Access Compliance Report Public Rights-of-Way (Curb Ramps)

Main Street: ROLLING_RIDGE		Cross Street: SHEA_RIDGE		Location:	S
ADA ID: RPRK211019142246	Ramp Type: Type 4 - Parallel	Initial Pass/Fail: Fail	Overall Compliance: No	Severity Score:	45
Codes/Mitigation Info/Possible Solution			Field Measurements/Component Compliance

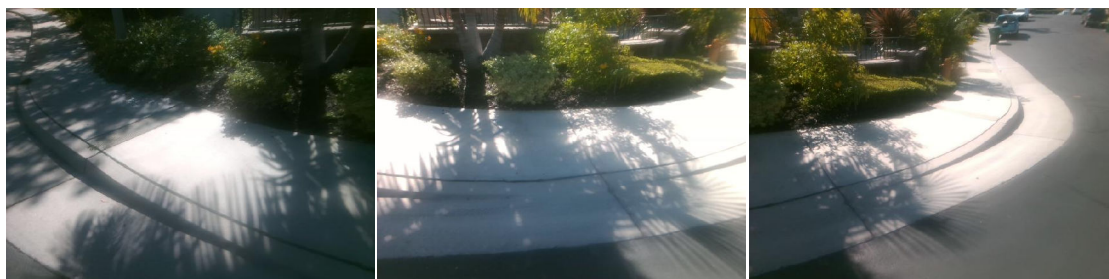
R204.3, R304.3.2, R304.5.3, R302.7.2, STD 1115

Compliance	Description	Data	Compliance	Description	Data
N/A	Ramp Length LT (in)	119	N/A	Ramp Length RT (in)	118
Yes	Ramp Width LT (in)	54	Yes	Ramp Width RT (in)	54
No	Ramp Run Slope LT (%)	9.1	No	Ramp Run Slope RT (%)	8.6
No	Ramp Cross Slope LT (%)	12.9	No	Ramp Cross Slope RT (%)	14.2
N/A	Landing Present	N/A	N/A	DWS Provided	N/A
N/A	Landing Length (in)	N/A	N/A	DWS Contrast	N/A
N/A	Landing Width (in)	N/A	N/A	DWS Length (in)	N/A
N/A	Landing Run Slope (%)	N/A	N/A	DWS Full Width	N/A
N/A	Landing Cross Slope (%)	N/A		DWS Offset Type	N/A
N/A	Landing Movement Obstructed?	N/A	N/A	DWS Offset Left (in)	N/A
	Landing Movement Type	N/A	N/A	DWS Offset Right (in)	N/A
N/A	Landing Shared	N/A			
N/A	Clear Space	Yes			
N/A	Clear Space To Crosswalk (in)	N/A			
N/A	Marked Crosswalk 1	No	N/A	Marked Crosswalk 2	No
	Crossing 1 Direction	NE		Crossing 2 Direction	NW
	Marked Crosswalk 1 Width (in)	N/A		Marked Crosswalk 2 Width (in)	N/A

N/A	Ramp Inside Crosswalk 1	N/A	N/A	Ramp Inside Crosswalk 2	N/A
	Crossing 1 Slope (%)	0.9		Crossing 2 Slope (%)	7.3
	Crossing 1 Cross Slope (%)	7.9		Crossing 2 Cross Slope (%)	1.2
N/A	Gutter Ponding	N/A	N/A	Curb Slope	7.3
No	Gutter Lip Height (in)	0.25		Road Run Slope (%)	4.6
N/A	Gutter Run Slope (%)	N/A		Road Cross Slope (%)	0.1
N/A	Gutter Cross Slope (%)	N/A	No	Perpendicular Joint Present	No
Yes	Overall Surface Condition	Acceptable			
	Cross Gutter Present?	No		Spandrel Present?	No
	Replace Cross Gutter?	N/A		Replace Spandrel?	N/A

Remove & Replace Curb Ramp With Two New Directional Ramps or Equivalent. Grind Gutter Lip.
